Power Inverter Diode Installation

November 21, 2016 Page **1** of **3**

Demers Chevrolet Ambulances

ISSUE: GM Recall "42230 Shortened Powered Accessory Availability" reprograms the vehicle's PCM and BCM for the alternator to produce more voltage. This higher voltage causes the ambulance power inverter to produce an "Over Voltage" trouble code, causing the power inverter to stop working.

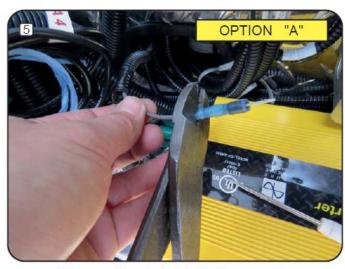
Use a screwdriver to remove wire.

Remove wire.

Crimp and heat shrink diode assembly.

Reinstall wire in connector.
